2.4 Core Cooling Systems

The information in this section of the reference ABWR DCD, including all subsections, tables, and figures, is incorporated by reference with the following departures.

STD DEP T1 2.4-1 (Figure 2.4.1a, Table 2.4.1)

STD DEP T1 2.4-2 (Figure 2.4.3)

Figure 2.4.1a Residual Heat Removal System (RHR-A)

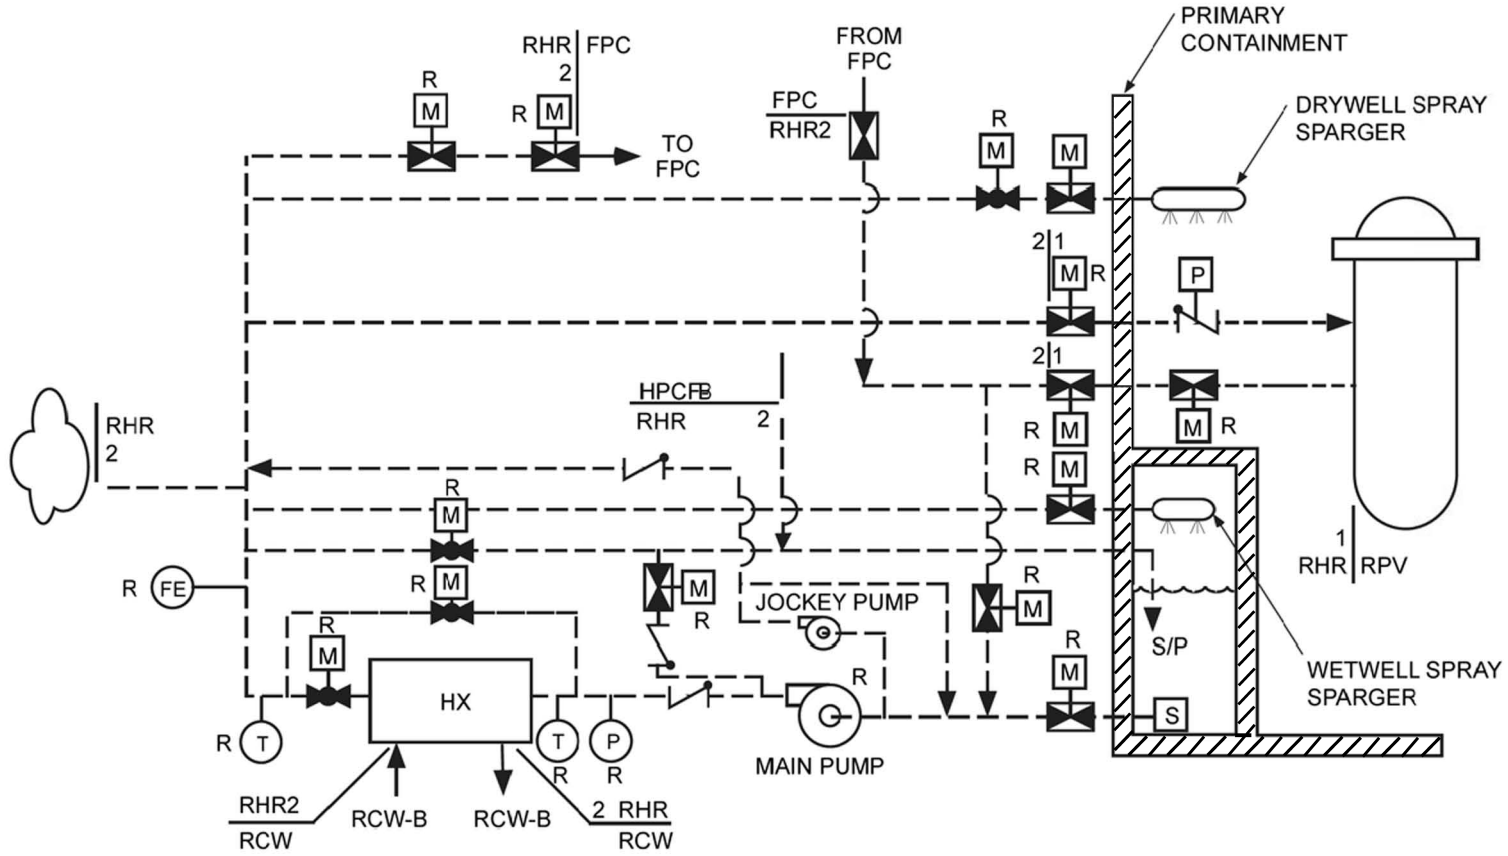
STD DEP T1 2.4-1

The augmented fuel pool cooling mode of the RHR System (Divisions A, B and C) can supplement the Fuel Pool Cooling (FPC) System as follows: (1) directly cooling the fuel pool by circulation fuel pool water through the RHR heat exchanger and returning it to the fuel pool; and (2) while providing shutdown cooling during refueling operations, return the cooled RHR shutdown cooling flow to the fuel pool. Also, this mode provides for fuel pool emergency makeup capability by permitting the RHR pumps (Divisions A, B and C) to transfer suppression pool water to the fuel pool. This mode is accomplished manually by control of individual system components. In the augmented fuel pool cooling mode, the RHR tube side heat exchanger flow rate for Divisions A, B or C is no less than 350 m³/h.

The piping and components outside the shutdown cooling suction line containment isolation valves and outside the suppression pool containment isolation valves, and upstream of the suction side of the pump with all its branches have a design pressure of 2.82 MPaG for intersystem LOCA (ISLOCA) conditions. Refer to Figures 2.4.1a, 2.4.1b, and 2.4.1c. ~~For RHR A, the upgraded branch lines from the main pump suction include the path to and including the suppression pool suction valve, the path to the shutdown cooling outboard containment isolation valve, and the path to the jockey pump's discharge check valve including the jockey pump's bypass return line. For RHR B and C, the upgraded branch lines include all the paths listed for RHR A plus the path to (and including the valve) the Fuel Pool Cooling System that branches off the shutdown cooling suction line, titled "From FPC."~~ For RHR A and B, the upgraded branch lines from the main pump suction include the path to and including the suppression pool suction valve, the path to the shutdown cooling outboard

containment isolation valve, the path to the jockey pump's discharge valve including the jockey pump's bypass line and the path to the (and including the valve) the Fuel Pool Cooling System that branches off the shutdown cooling suction, titled, "From FPC." For RHR-C, the upgraded branch lines include all the paths listed for RHR-A and B plus the pipeline and valves that are part of the AC independent water addition mode that extends from the noncode boundary indicated by "NNS" to the "external connection" outside the "reactor building" and to the Fire Protection System interface indicated by "FP."

Figure 2.4.1b Residual Heat Removal System (RHR-B)

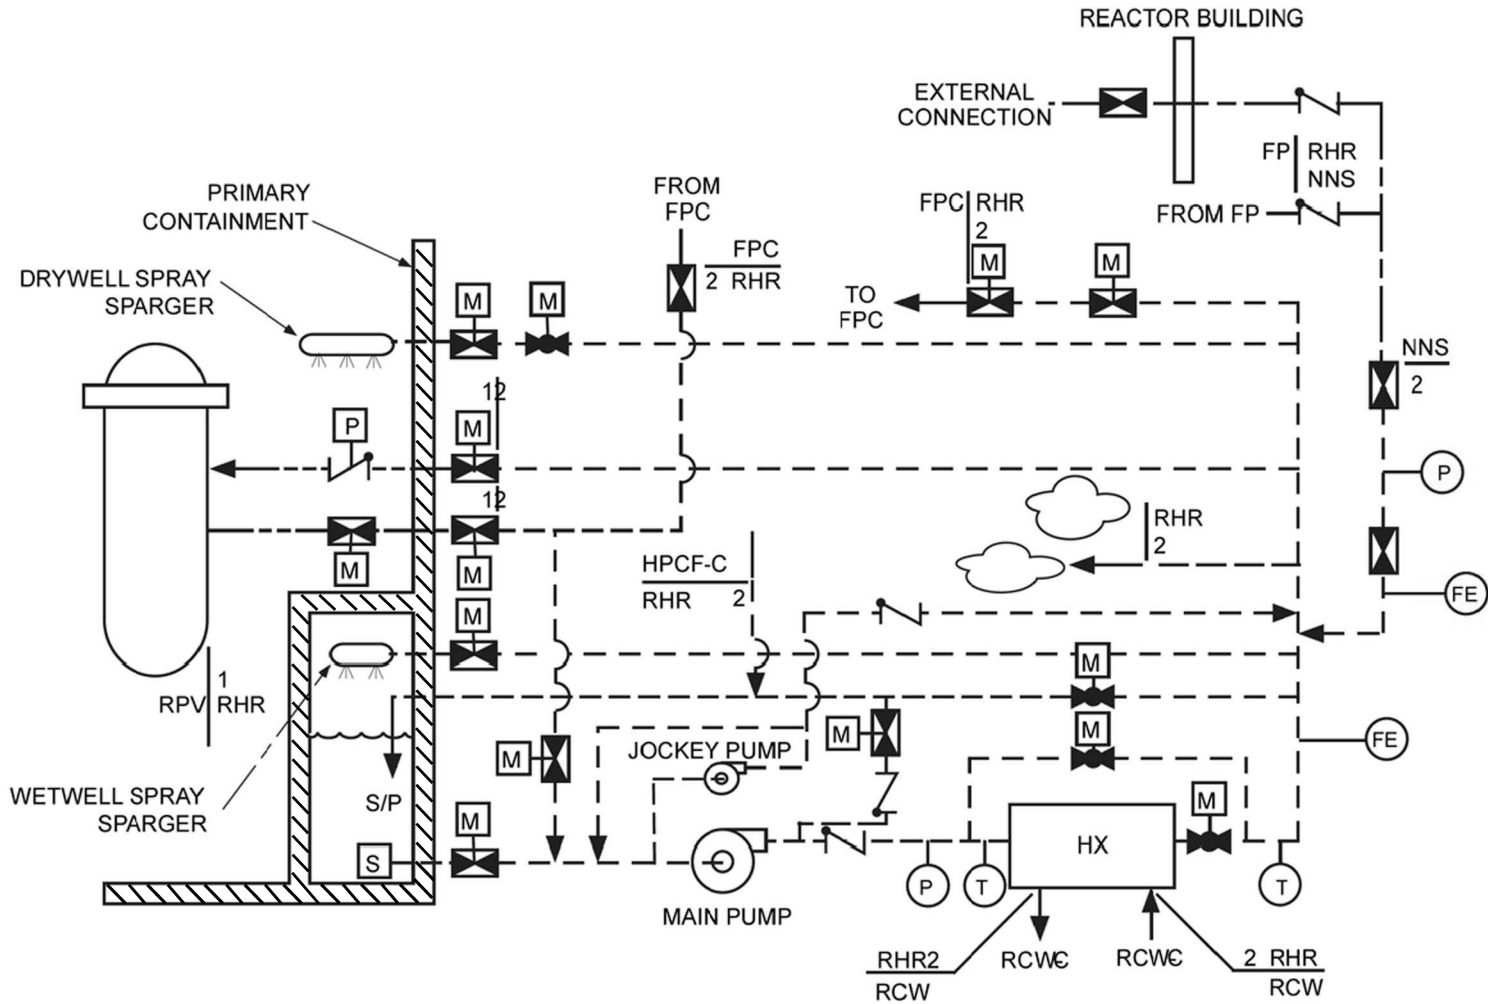
STD DEP T1 2.14-1 (Figure 2.4.1b, Figure 2.4.1c, Figure 2.4.3)

1. ALL ELECTRICAL POWER LOADS FOR THE CLASS 1E COMPONENTS SHOWN ON THIS FIGURE ARE POWERED FROM CLASS 1E DIVISION II EXCEPT FOR THE OUTBOARD CONTAINMENT ISOLATION VALVE OF THE SHUTDOWN COOLING SUCTION LINE, WHICH IS DIVISION III.
2. DRYWELL AND WETWELL SPRAY SPARGERS ARE COMMON TO DIVISIONS B AND C.

Figure 2.4.3 Leak Detection and Isolation System Interface Diagram

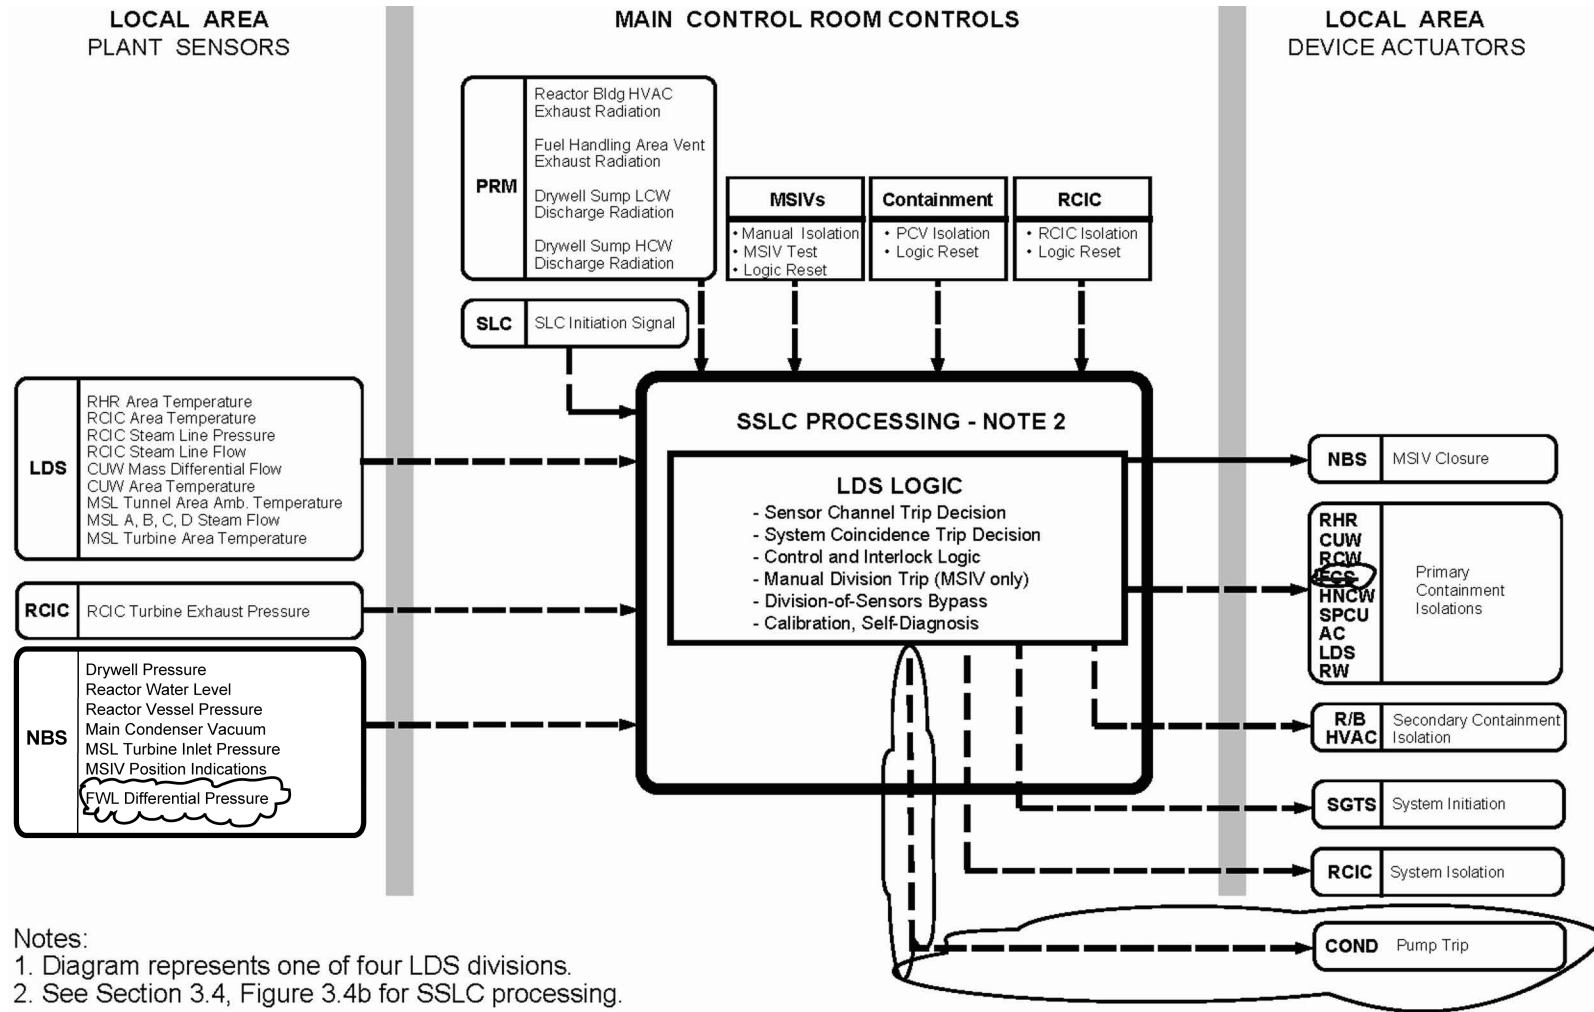
STD DEP T1 2.4-2 (Leak Detection System), Figure 2.4.3

STD DEP T1 2.14-1 (FCS, Figure 2.4.3)

- (9) *Isolation of the Suppression Pool Cleanup (SPCU) System on a signal indicating high drywell pressure or low reactor water level.*
- ~~(10) *Isolation of the Flammability Control System (FCS) on a signal indicating high drywell pressure or low reactor water level.*~~

- (10) ~~(11)~~ *Isolation of the drywell sump low conductivity waste (LCW) and high conductivity waste (HCW) discharge lines on a signal indicating high drywell pressure or low reactor water level. Also, each discharge line is individually isolated on a signal indicating high radioactivity in the discharged liquid waste; only one channel is used for this function.*

- (11) ~~(12)~~ *Isolation of the LDS fission products monitor drywell sample and return lines on a signal indicating high drywell pressure or low reactor water level.*

- (12) ~~(13)~~ *The LDS provides to the neutron monitoring system a signal indicating a high drywell pressure or low reactor water level.*
- (13) *The LDS provides a trip of the condensate pumps on signals that indicate high drywell pressure and high differential pressure between the feedwater lines.*

Figure 2.4.4a Reactor Core Isolation Cooling System

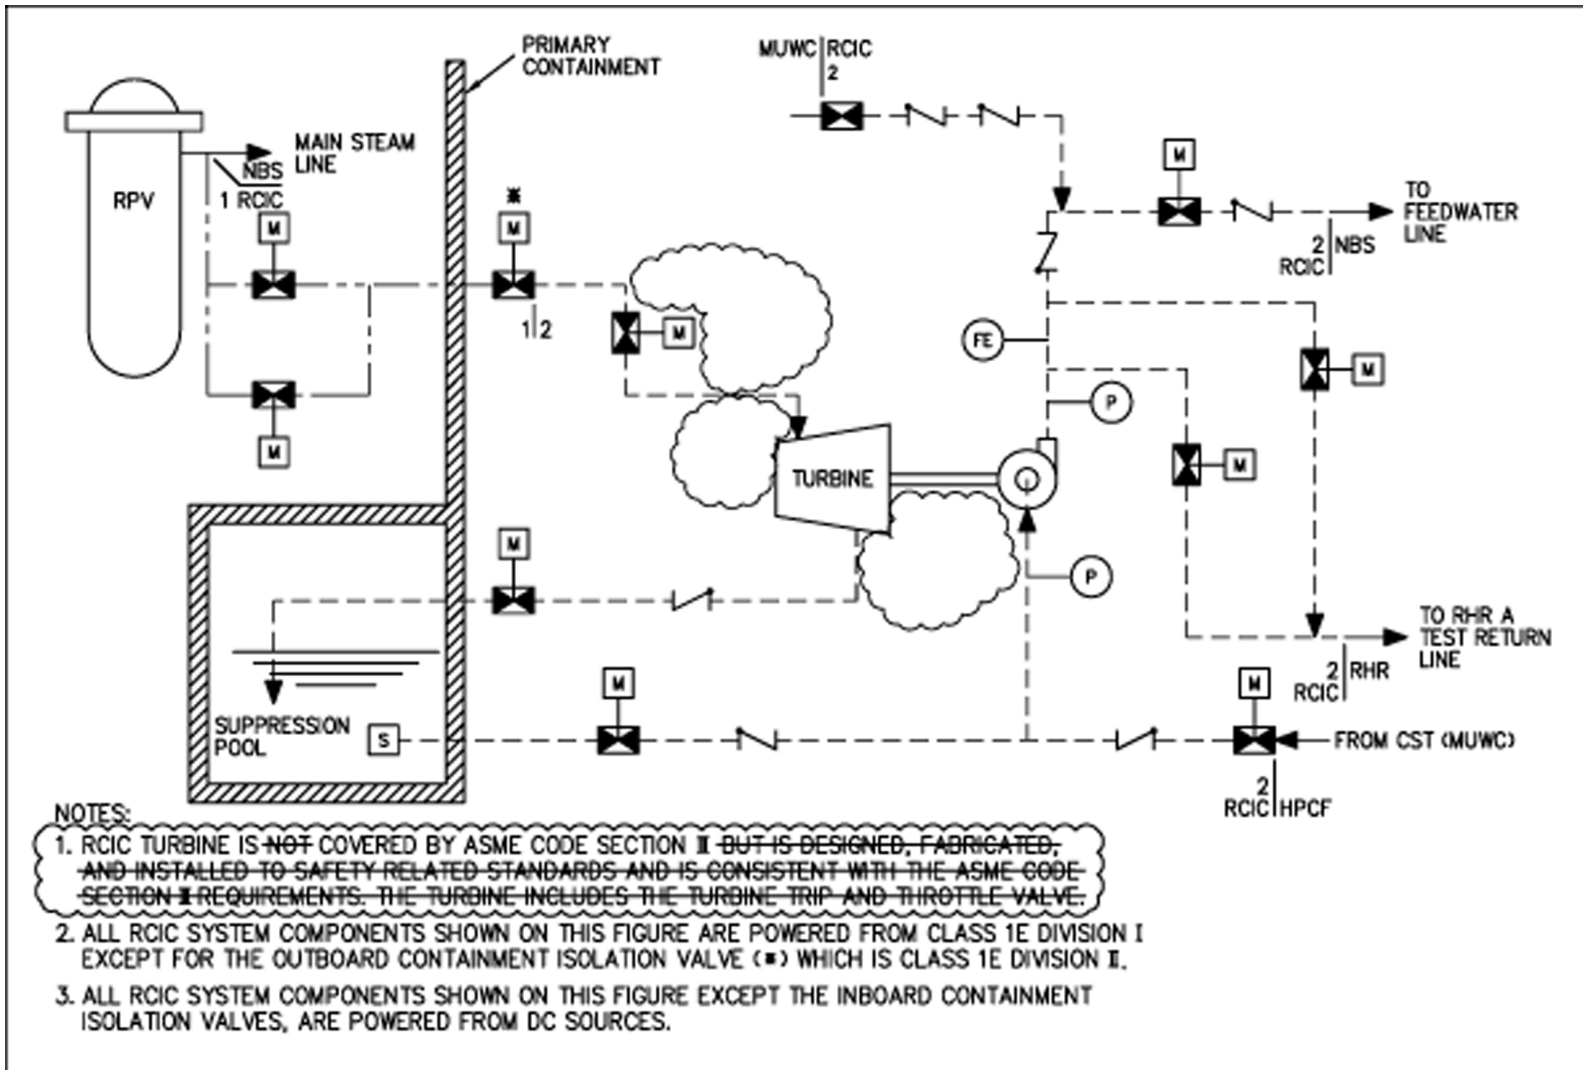
STD DEP T1 2.4-3

~~The Reactor Core Isolation Cooling System (RCIC) alternate design description was provided in ABWR Licensing Topical Report NEDE-32000P, "Advanced Boiling Water Reactor (ABWR) with Alternate RCIC Turbine Pump Design," dated December 20, 2006. This information on pages C-2 through C-6 of the Licensing Topical Report is incorporated by reference.~~

- (1) Parameter displays for the instruments shown on Figure 2.4.4a.
- (2) Controls and status indication for the active safety-related components shown on Figure 2.4.4a.
- (3) Manual system level initiation capability for RPV water makeup mode.
- (4) Manual override of the automatic CST to S/P suction transfer.

- (1) Piping and component from the pump suction MOV's up to the pump inlet,
- (2) ~~Barometric condenser and associated equipment.~~

have a design pressure of 2.82 MPaG for intersystem loss-of-coolant accident (ISLOCA) conditions.
